Russell Gap Stream Mitigation Project Year 2 (2021) Monitoring Report FINAL

DMS Project ID No. 100003, DEQ Contract No. 6980

Subject: Response to DMS Comments for DRAFT MY2 Report
Russell Gap Mitigation Project, Alexander County
DMS Project # 100003, DEQ Contract #6980, Catawba River Basin

Table 5. Visual Stream Morphology Stability Assessment - Assessed October 2021
 Russell Gap Stream Mitigation Project - NCDMS Project No. 100003

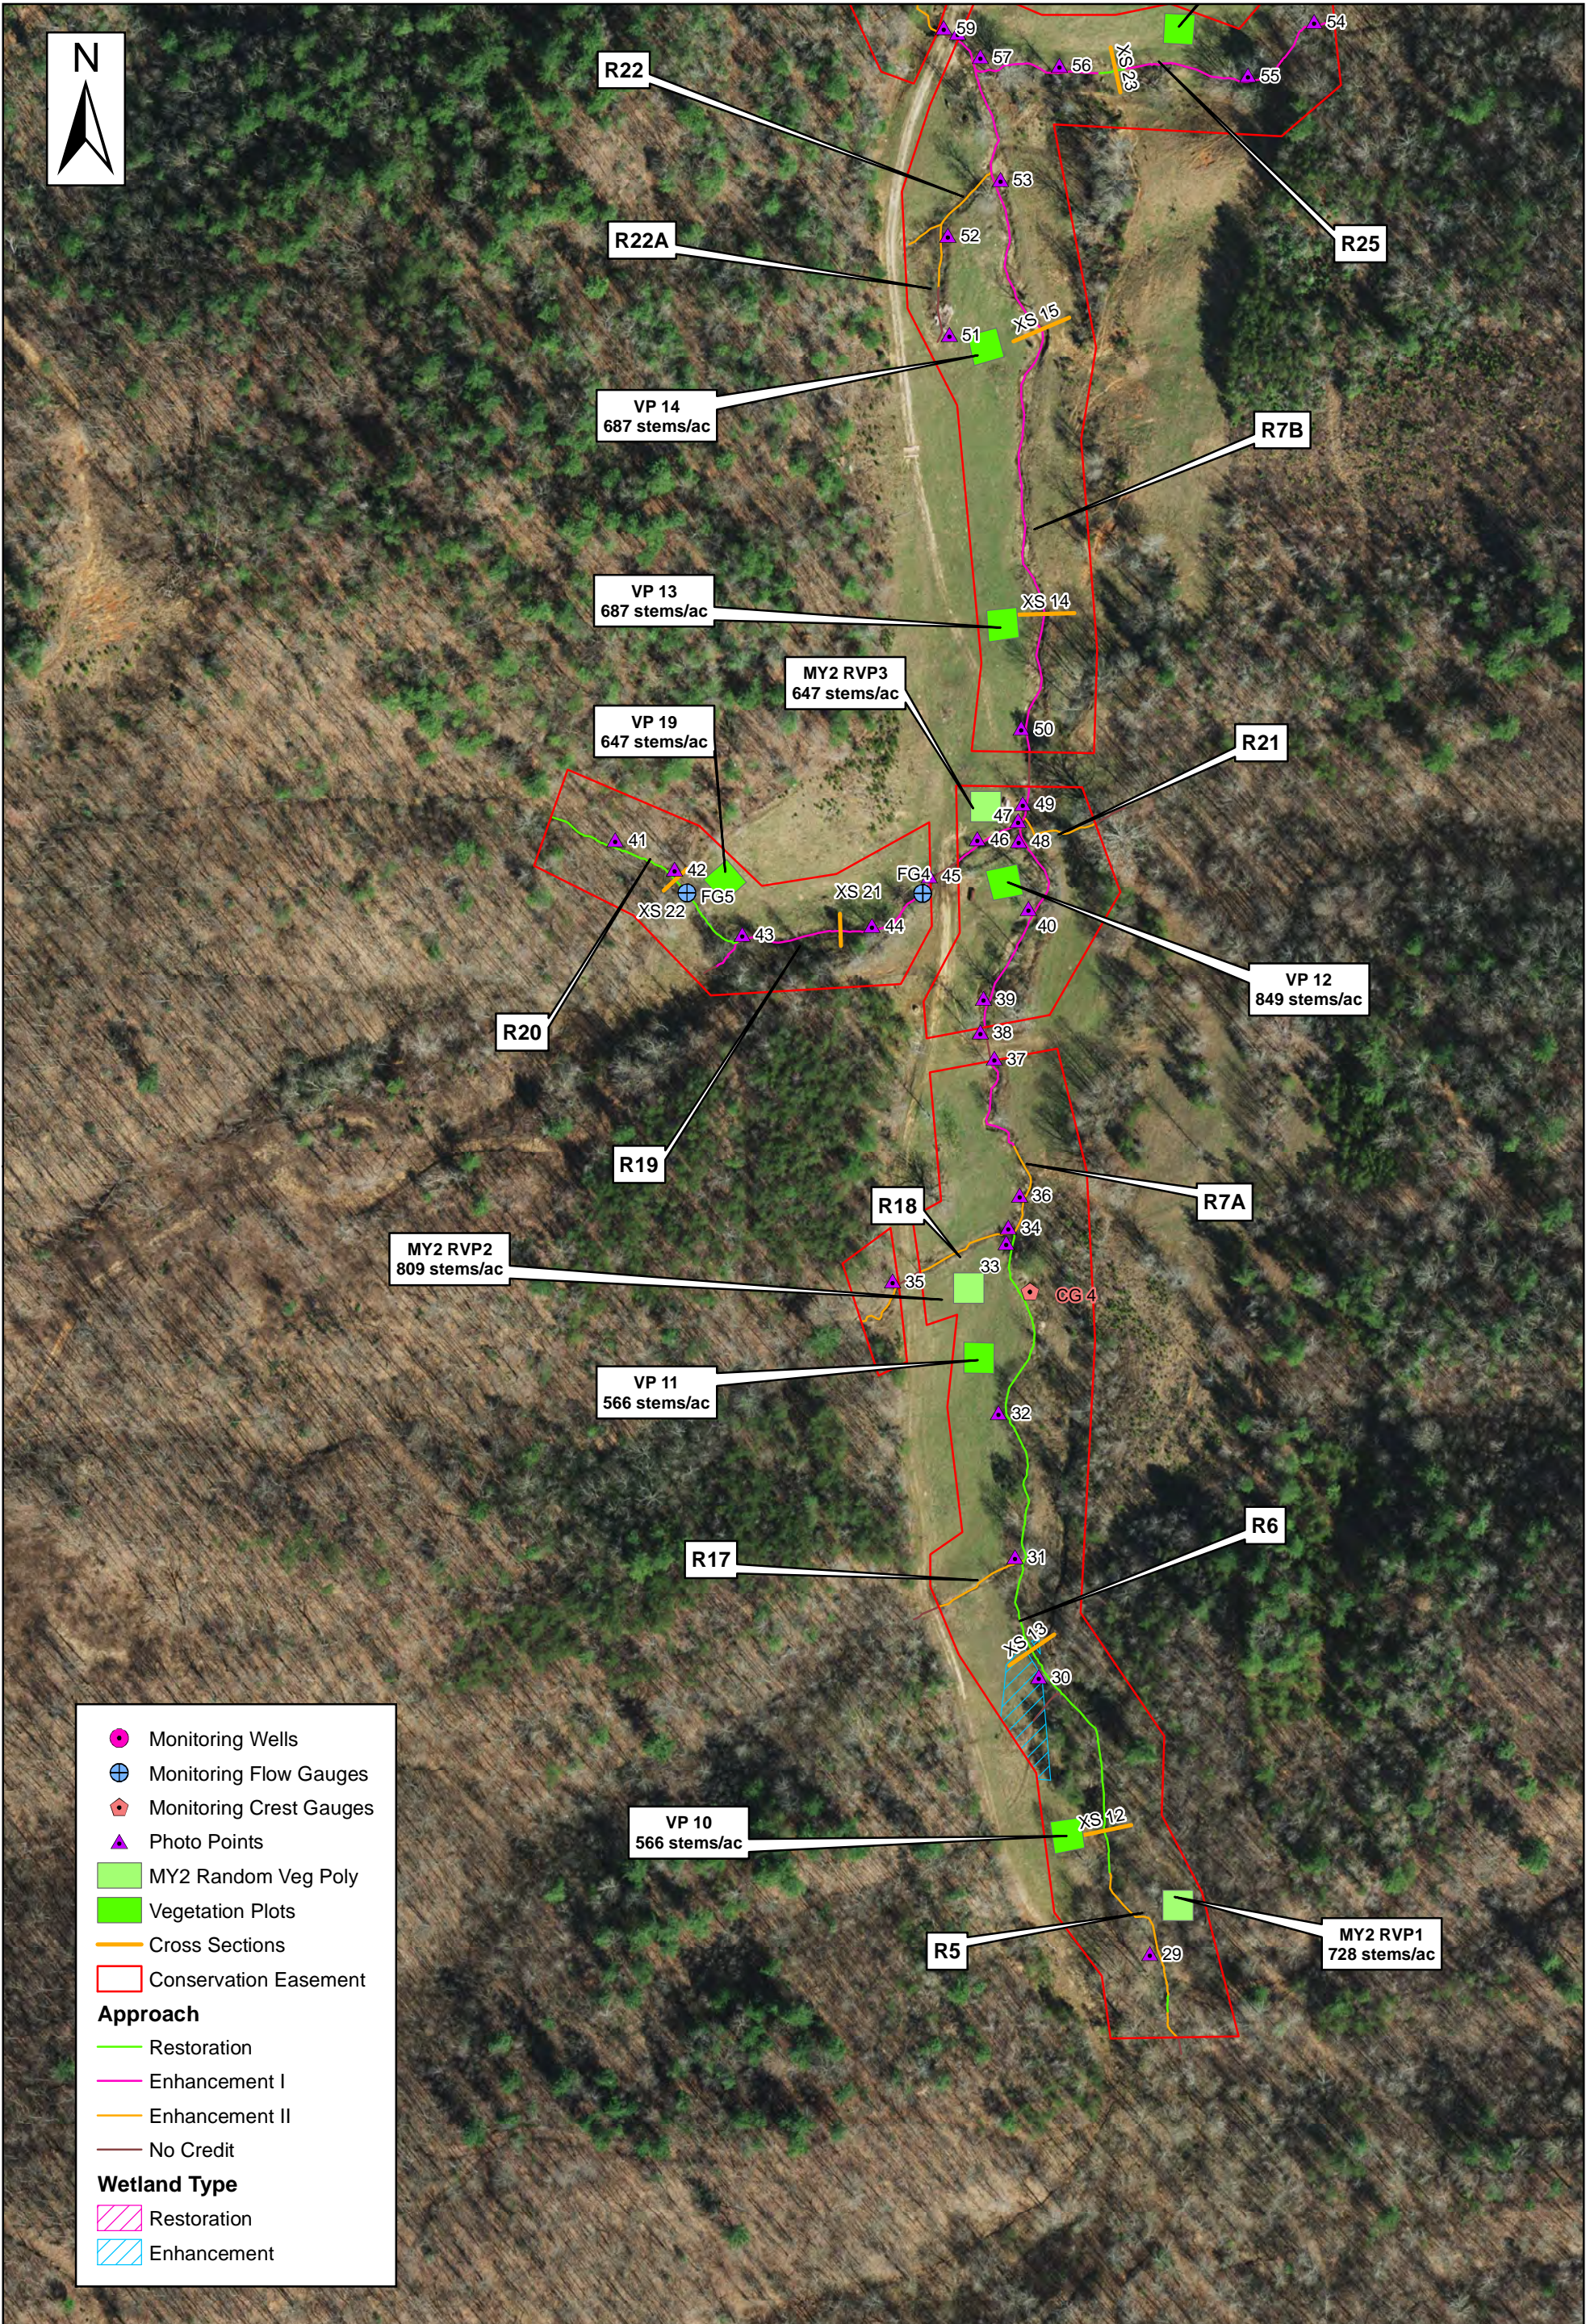
- Please include IRT meeting minutes from the June 23, 2021 site visit in the appendix.
Response: IRT meeting minutes have been included in Appendix F.
- Please include encroachment discussed in section 1.4 Monitoring Results on CCPV.

- CCPV: Include all areas that were repaired and replanted on CCPV.
Response: Repair areas have been added to the CCPV.
- Table 5 and 6: Please add dates to the tables to indicate when the field assessment was completed for the Stream Stability Assessment and Vegetation Assessment. The IRT has requested this information be included on these tables.

- Please include features representing the scoured eroding area along R1 and R4a and display these segments in the CCPV.
Response: These areas are shown as "Stream Problem Areas" on the CCPV and the shapefile has been included with the electronic deliverables.

Response: The encroachment area has been added to the CCPV as a shapefile.
- Section 1.4 states 64.4 inches of rainfall was observed for the project and the annual historic average is 56.1 inches. Figure 7 note states historic average annual rainfall is 52.51 inches while the observed project rainfall was 55.76 inches. Please review and revise as necessary.
